STONEBRIAR ADDITION

WICHITA, SEDGWICK COUNTY, KANSAS

Re: S/D 96-32 STONEBRIAR ADDITION (One Step Preliminary-Final Plat)

At the regular meeting of the Subdivision Committee of the Metropolitan Area Planning Commission on Wednesday, July 3, 1996, the above captioned plat was considered. The action of the Committee was to recommend that this plat be approved subject to:

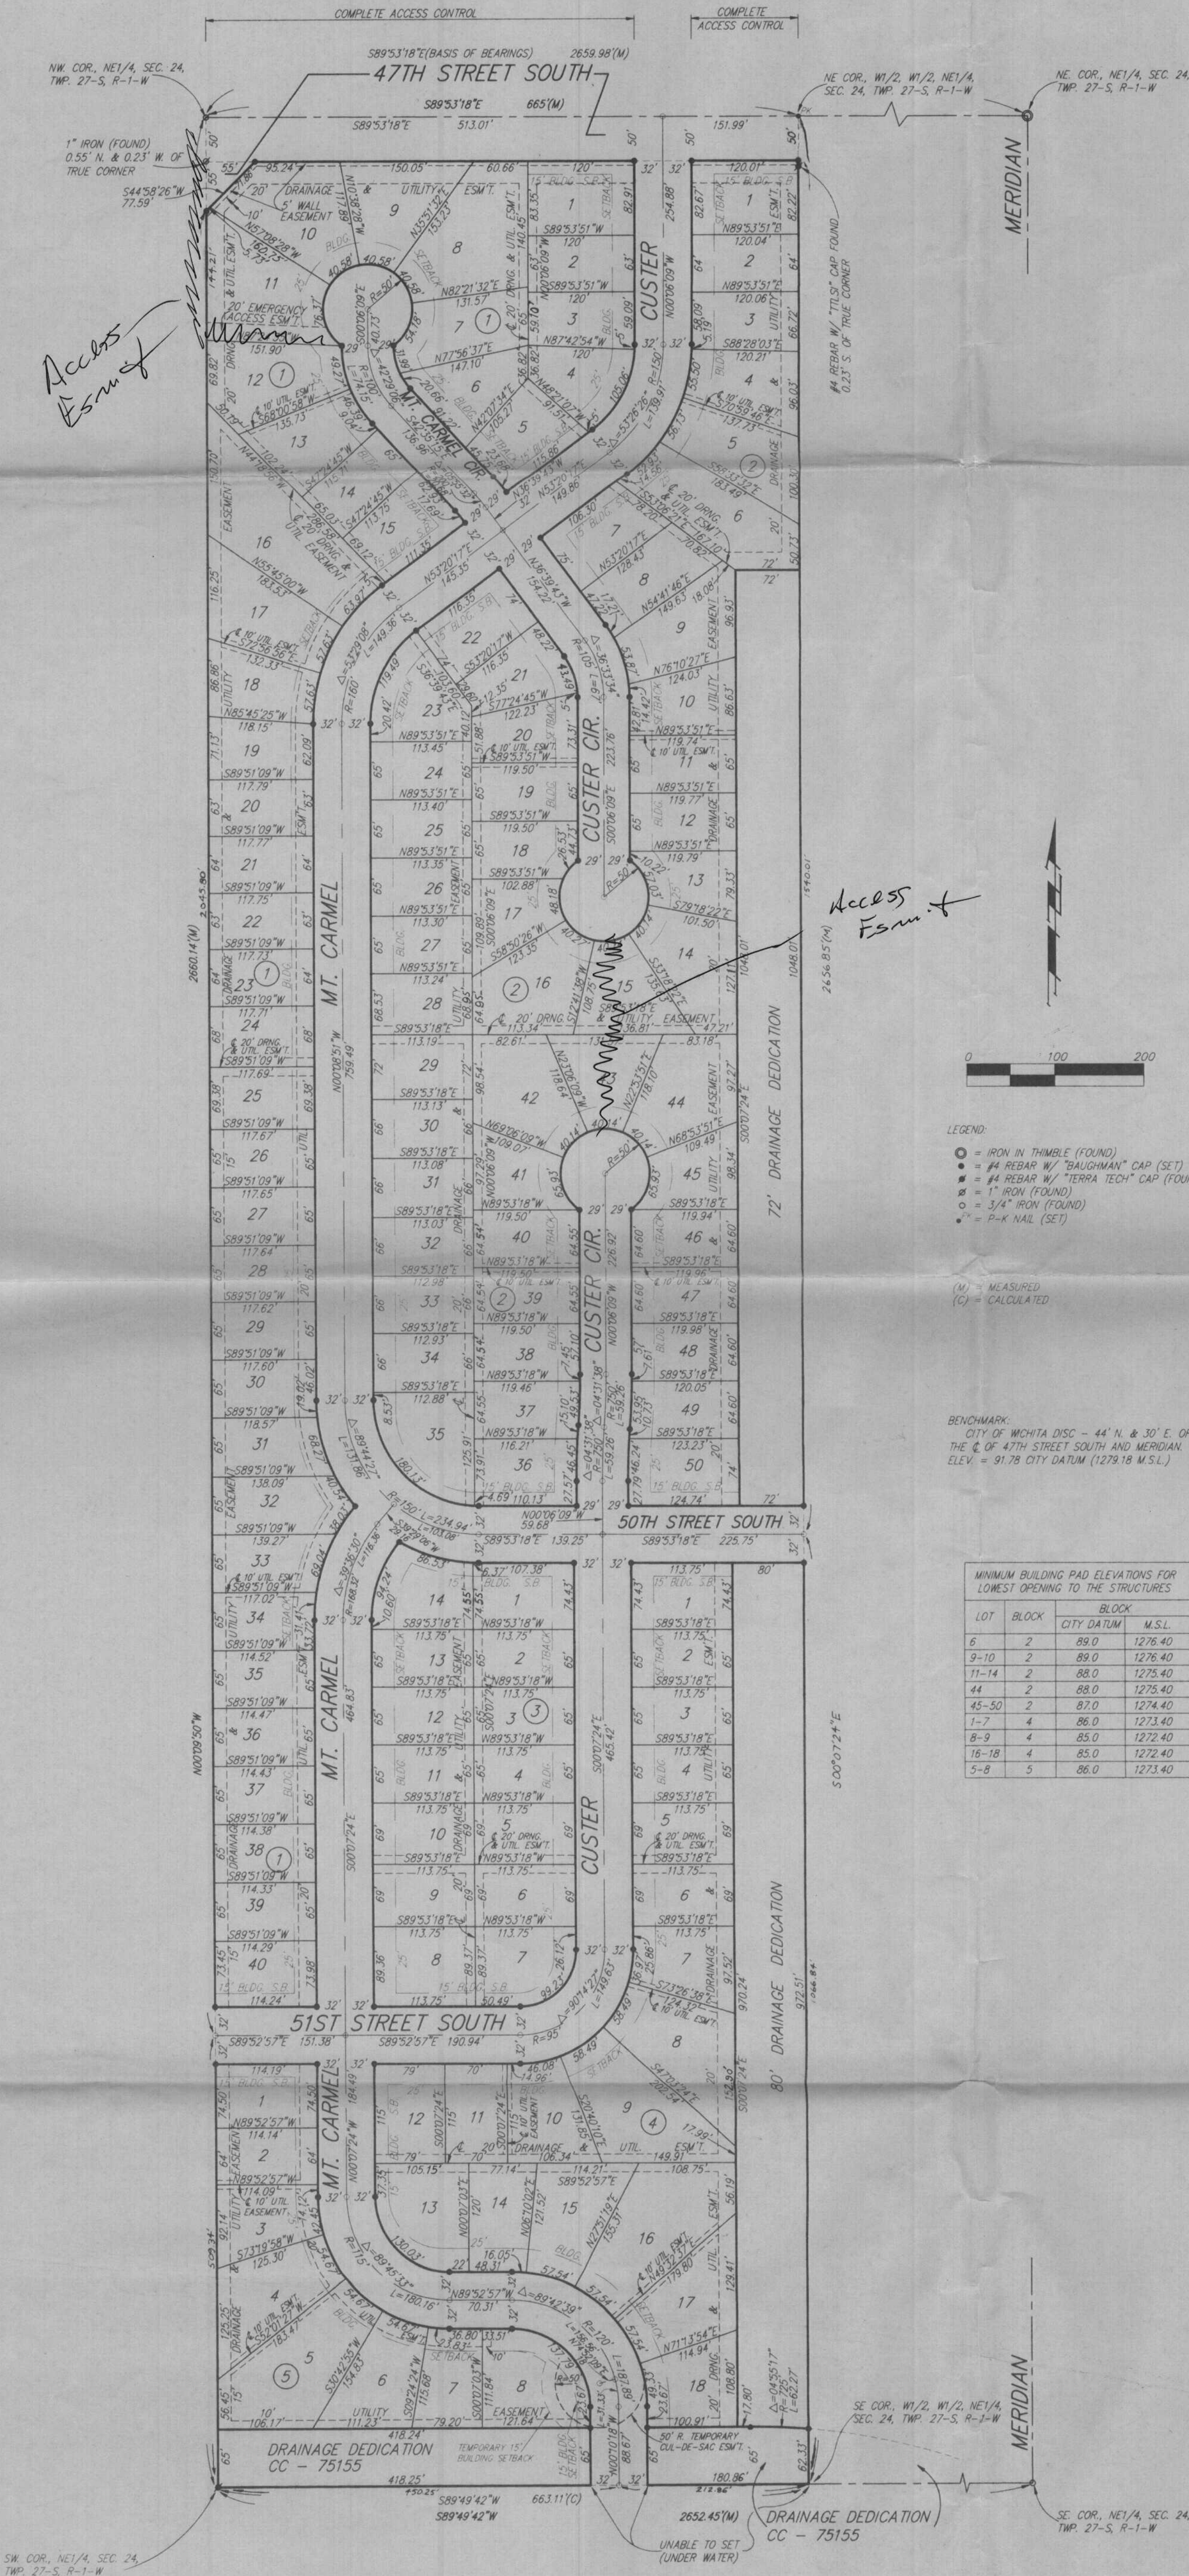
- ☒ E. The applicant shall guarantee the paving of the proposed interior streets. This guarantee shall include sidewalk along one side of all non-cul-de-saced streets, including any street stub sections and streets ending in a permanent or temporary turnaround. Also, this guarantee shall provide for a temporary or permanent turnaround at the site's southern line (for Custer). However, Custer's right-of-way shall in any case, extend to the south line of this plat.

- ~~I.~~ On the final plat tracing, complete access control shall be dedicated to 47th street South from the adjacent lots.
- (J.) Prior to submitting the final plat tracing, the applicant shall meet with City Engineering to determine if a drainage dedication will be accepted or if the involved area needs to be platted as a Reserve. As requested by City Engineering, additional information needs to be provided in regard to the cross section of the drainage way and the available areas either side for access and maintenance of any such dedication. If the area is platted as a Reserve, this plat will be subject to the standard requirements for such Reserve areas. If a dedication is accepted, the plat shall also note that this area is available for public use as a recreational bike and hike, etc. area.

- ~~K.~~ *see note on improvement unit. sheet submitted by appli*
The applicant shall either provide a covenant restricting development of lots south of 50th Street South until another means of acceptable access is provided to this site (public street extended to this plat's indicated street stubs) or an acceptable area is provided for an emergency access easement and a guarantee submitted to install an appropriate all-weather driving surface. The applicant is encouraged to consider such an easement in conjunction with the above noted drainage dedication/Reserve.

- (L.) Based on the platting binder, a blanket pipeline easement apparently covers this site. Prior to this plat being released for recording, the applicant shall provide proof that this easement has been released. If confined, and located any where on this site, this plat will be subject to the standard requirements concerning pipelines and pipeline easements.

- ~~M.~~ The preliminary plat is presently indicating 3 of the plat's 4-corners as being tied to the N.W. corner of this quarter section. On the final plat tracing, any such corner references shall note a proper corner (NE, SE, etc.).

- T. The final plat shall indicate the utility easements requested by K.G.& E. and Southwestern Bell which are indicated on the enclosed "marked" copy of the plat. The applicant is also encouraged to discuss with the utilities (KG&E and S.W. Bell) the appropriateness of platting 20-foot, combined drainage and utility easements for this site. If necessary, the final plat shall revise such easements (increase their widths, drop drainage use, etc.)
